7.0 Instrumentation and Control Systems

7.1 Introduction

The information in this section of the reference ABWR DCD, including all subsections and tables, and figures, is incorporated by reference with the following departures and supplements.

Figure 7.1-1 ~~SSLC Self-Test System~~ Diagnosis

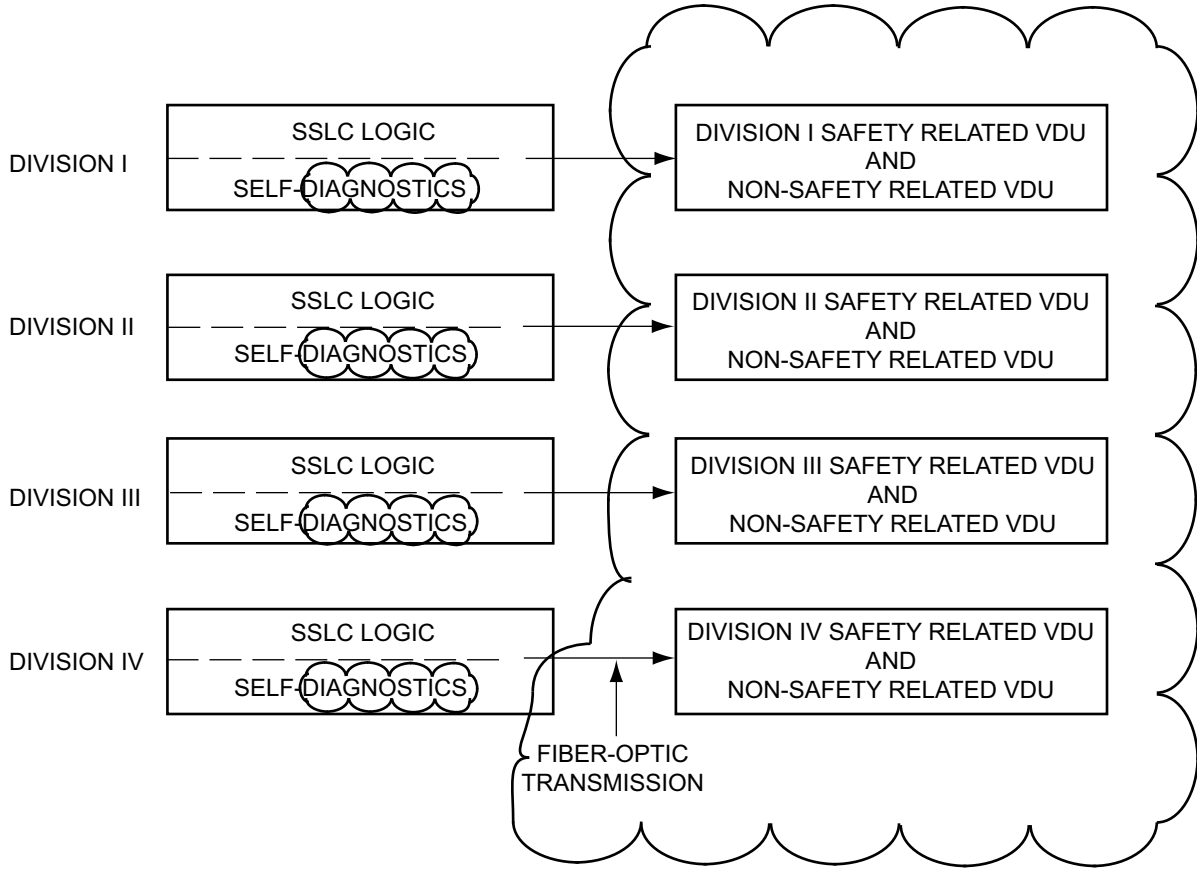
STD DEP T1 3.4-1 (Figure 7.1-1, 7.1-2)

Each individual safety-related system utilizes redundant channels of safety-related instruments for initiating safety action. The automatic decision making and trip logic functions associated with the safety action of several safety-related nuclear steam supply systems (NSSS) are accomplished by ~~a four division correlated and separated protection logic complex called the safety system logic and control (SSLC)~~. The SSLC includes multiple redundant divisions, which are separated from each other. The SSLC has four redundant divisions of sensors. Each division of sensors has a corresponding division that determines the trip status of the safety functions relative to the safety function setpoint. The SSLC has four redundant divisions for all actuation functions except for the engineered safety features. The engineered safety features have three divisions, corresponding to the maximum redundancy of the engineered safety features actuated components. Some engineered safety features functions are less than three-fold redundant and are assigned to the appropriate set of redundant divisions. The SSLC multi-divisional complex includes divisionally separate control room and other panels which house the SSLC equipment for controlling the various safety function actuation devices. The SSLC receives input signals from the redundant

~~Divisional separation is also applied to the essential multiplexing system (EMS), which provides data highways for the sensor input to the logic units and for the logic output to the system actuators (actuated devices such as pump motors and motor operated valves). Systems which utilize the SSLC are include: (1) Reactor Protection (trip) System; (2) High Pressure Core Flooder System; (3) Residual Heat Removal System; (4) Automatic Depressurization System; (5) Leak Detection and Isolation System; (6) Suppression Pool Temperature Monitoring System; and (7) Reactor Core Isolation Cooling System. The equipment arrangement for these systems and other supporting systems is shown in Figure 7.1-2.~~
